# EASTERN CORRIDOR SEGMENTS II AND III (PID 86462)

## COMBINED LINWOOD/EASTERN INTERCHANGE & US 50/RED BANK INTERCHANGE FOCUS AREA

### ADVISORY COMMITTEE MEETING NOTES

## MEETING #4 NOTES

**Continuous Right Turn  
Lane From SR 125 to  
Wooster**

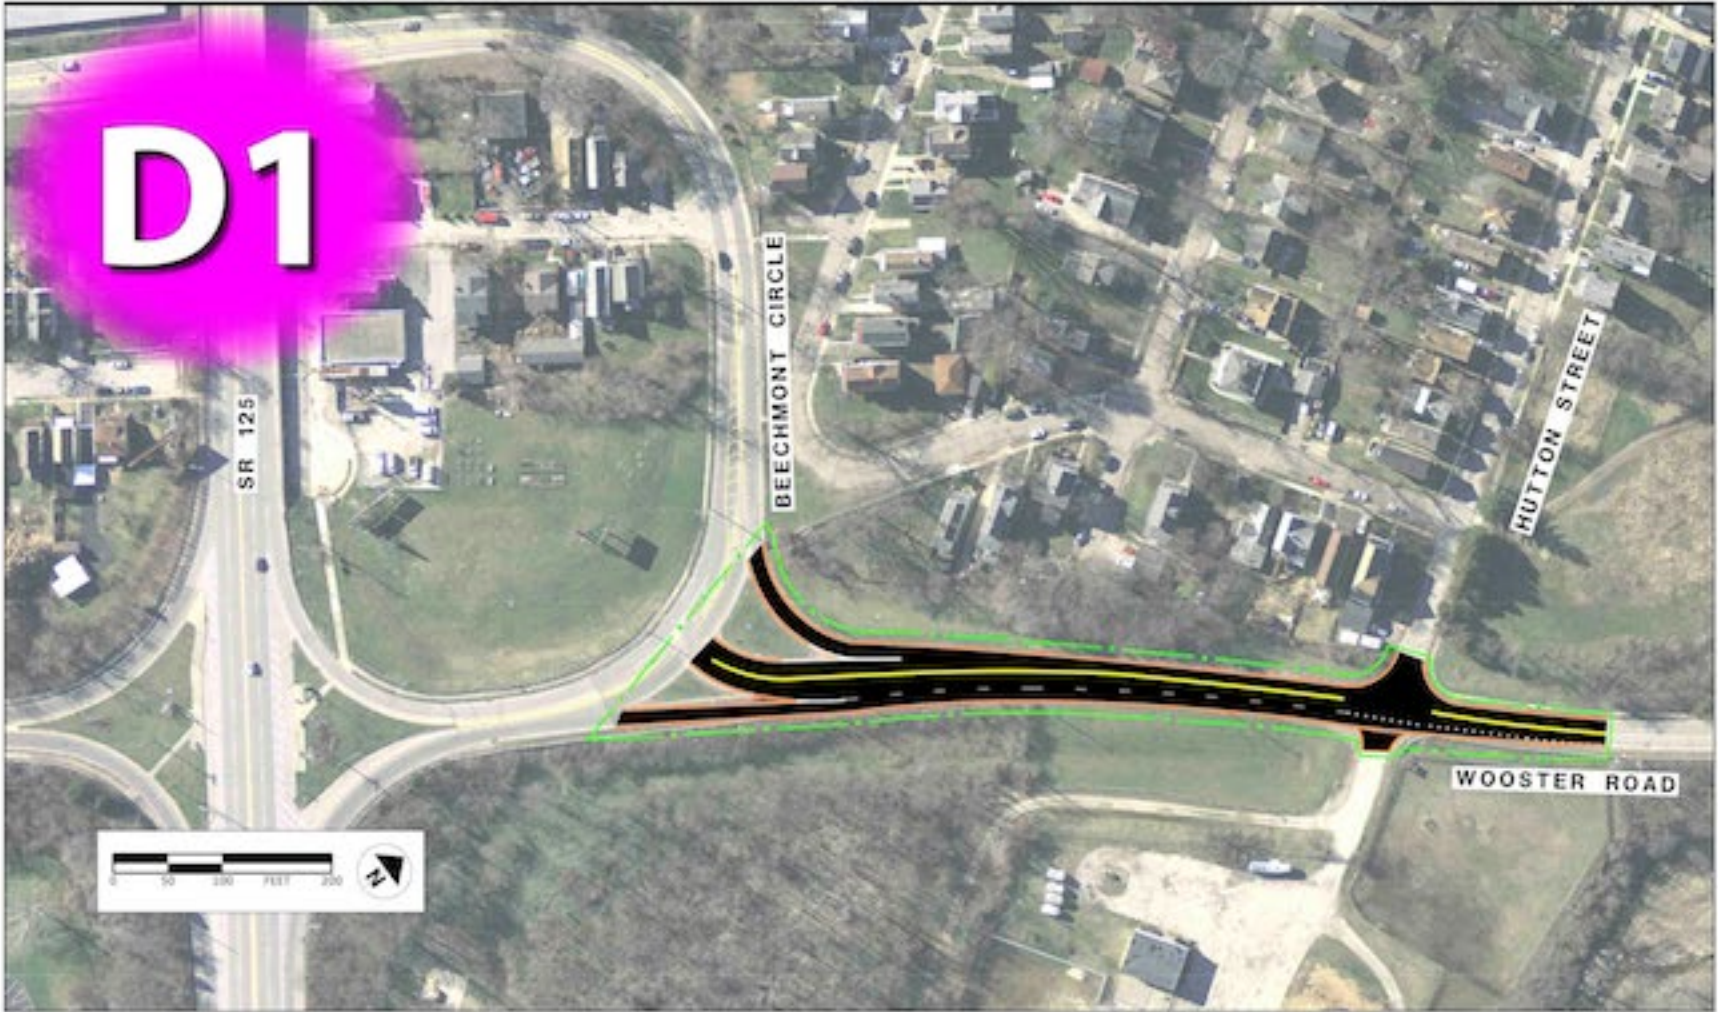
- There have not been many accidents/crashes have been recorded in this area.
- The City of Cincinnati completed improvements in this area from Beechmont Circle to Hutton Street (including the addition of new sidewalks) this past fall.

- Right turning vehicles must yield to left turning vehicles.
- No additional comments received following the 5/22 meeting.

- Concept removes the median on Wooster to allow for two lanes. This creates a continuous right turn lane at Beechmont Circle for turns onto Wooster from SR 125, so those drivers can merge instead of coming to a yield line. The concept includes minimal widening.
- No additional comments received following the 9/7 meeting.

- Include concept in the Implementation Plan as a low priority.

### Grade Separated Interchange Connecting Wilmer and Wooster

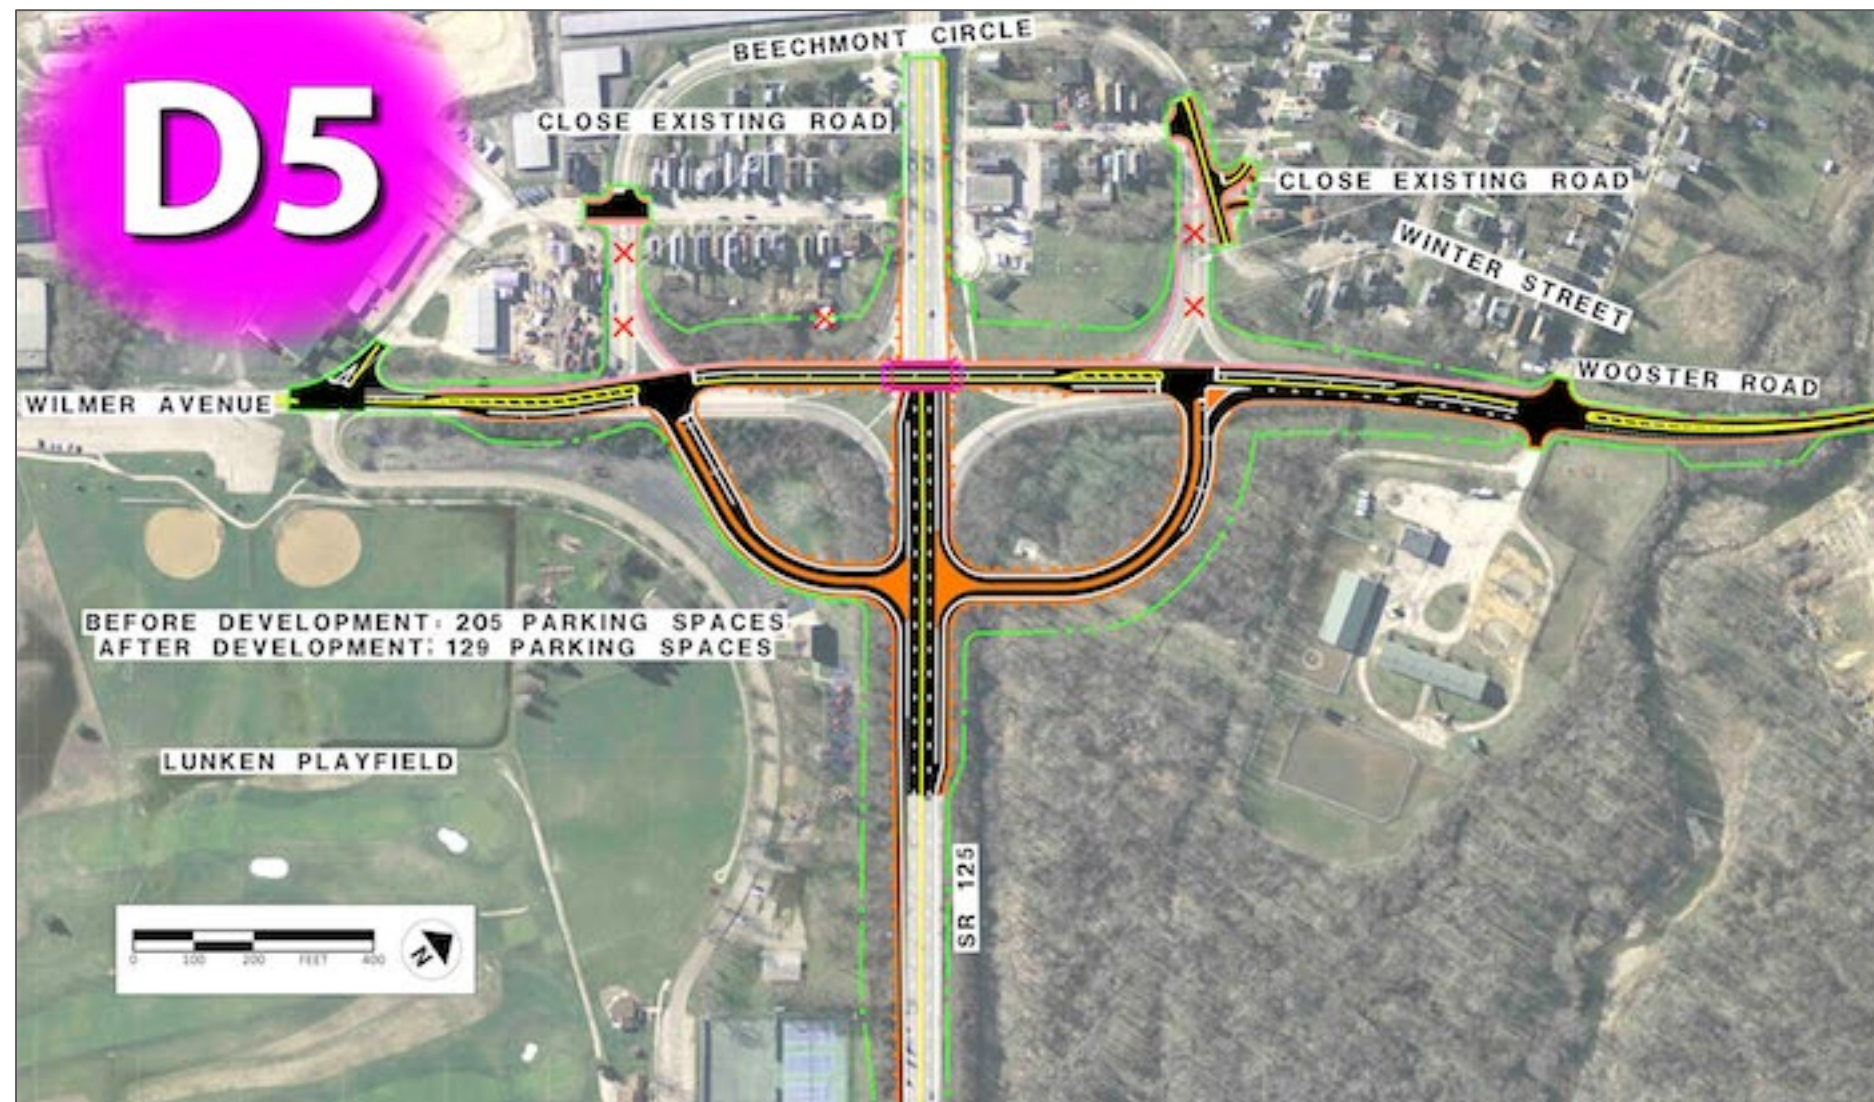
- A key difference between the two concepts is that X-2b-2a (D6) includes an at-grade railroad crossing and creates four-way signalized ramp intersections while X-2b-2 (D5) creates three-way signalized ramp intersections.
- Concept X-2b-2a (D6) appeared to have more interest from the public, but this concept would be difficult to fund.

- The City noted that they don’t see these projects as high priorities.
- It was suggested that ODOT/Stantec explore separate alternatives that would protect pedestrians without the road improvement components (i.e. a refuge island, improved signage, traffic calming, etc.).

- For some committee members, a primary concern relative to pedestrian safety was the location of the bus stop on Beechmont Circle. The group discussed the possibility of adjusting the bus stop to provide space for buses to pull off the road instead of stopping on the shoulder.

- The group also discussed adding more signage to alert drivers that the speed limit is reduced in this area from 45 mph to 35 mph, which could help to improve pedestrian safety and make crossing Beechmont easier and safer.

- It was noted that the study team has already looked at overpass, underpass and HAWK options; however, those fell out of consideration following discussions during previous meetings. Based on feedback from the City, the consultant team will look for other low cost alternatives.

- Revisit concepts/perform additional study to determine if a lower-cost option can be developed to improve pedestrian safety.
- Engage the Linwood Community Council to further vet the two concepts [X-2b-2 (D5) and X-2B-2A (D6)].
- Include X-2b-2 (D5) and X-2B-2A (D6) in the Implementation Plan as low priorities.

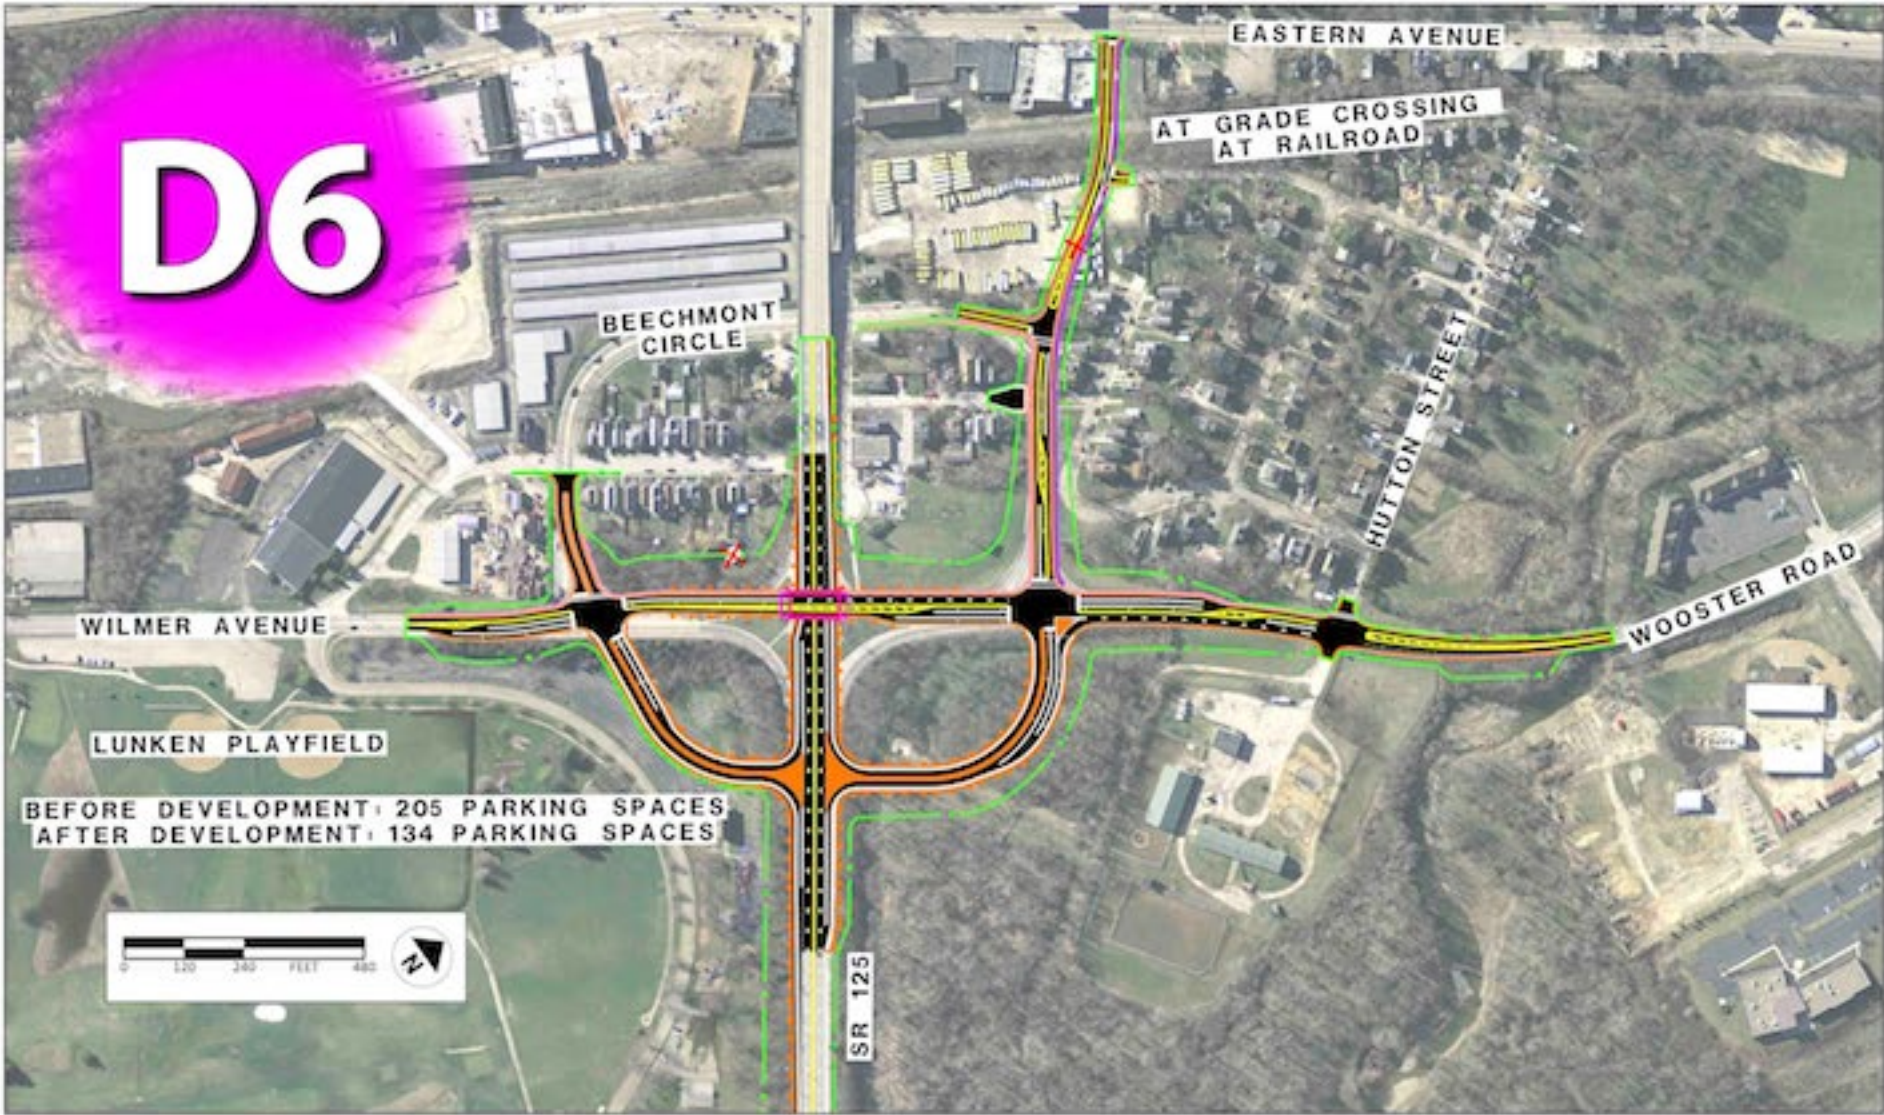
- A key difference between the two concepts is that X-2b-2a (D6) includes an at-grade railroad crossing and creates four-way signalized ramp intersections while X-2b-2 (D5) creates three-way signalized ramp intersections.

- For some committee members, a primary concern relative to pedestrian safety was the location of the bus stop on Beechmont Circle. The group discussed the possibility of adjusting the bus stop to provide space for buses to pull off the road instead of stopping on the shoulder.

- The group also discussed adding more signage to alert drivers that the speed limit is reduced in this area from 45 mph to 35 mph, which could help to improve pedestrian safety and make crossing Beechmont easier and safer.

- It was noted that the study team has already looked at overpass, underpass and HAWK options; however, those fell out of consideration following discussions during previous meetings. Based on feedback from the City, the consultant team will look for other low cost alternatives.

- Revisit concepts/perform additional study to determine if a lower-cost option can be developed to improve pedestrian safety.
- Engage the Linwood Community Council to further vet the two concepts [X-2b-2 (D5) and X-2B-2A (D6)].
- Include X-2b-2 (D5) and X-2B-2A (D6) in the Implementation Plan as low priorities.

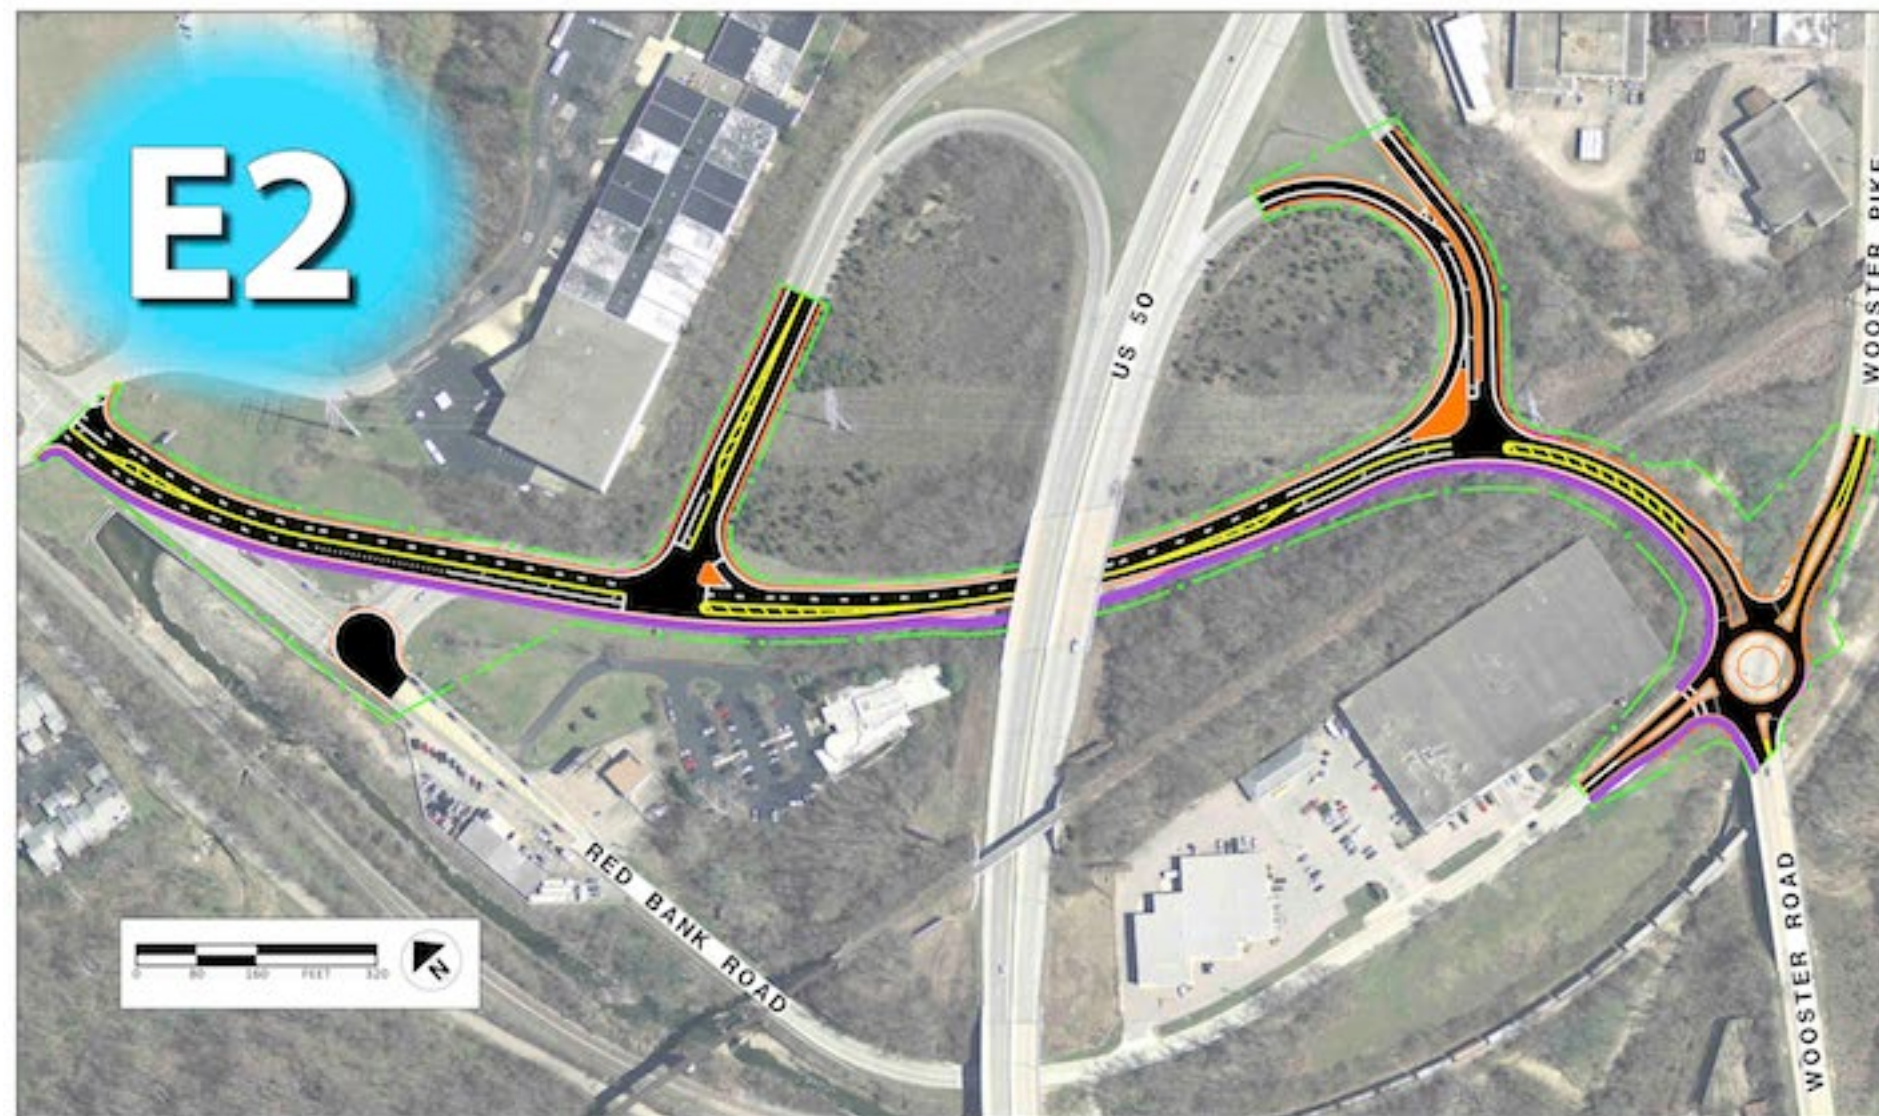
- The roundabout is designed for full semi-truck utilization.
- No additional comments received following the 9/7 meeting.

- This concept was presented as E2 at the October Open House meetings.
- A benefit of this concept is that it opens up a new bicycle/pedestrian corridor option.
  - The committee agreed to no longer pursue the roadway element of this concept.
  - The committee agreed that the roundabout at Wooster Road and the addition of the shared-use path in this alignment should be advanced as part of other projects [I-20b (E4) or BIKE-4a (E7)].
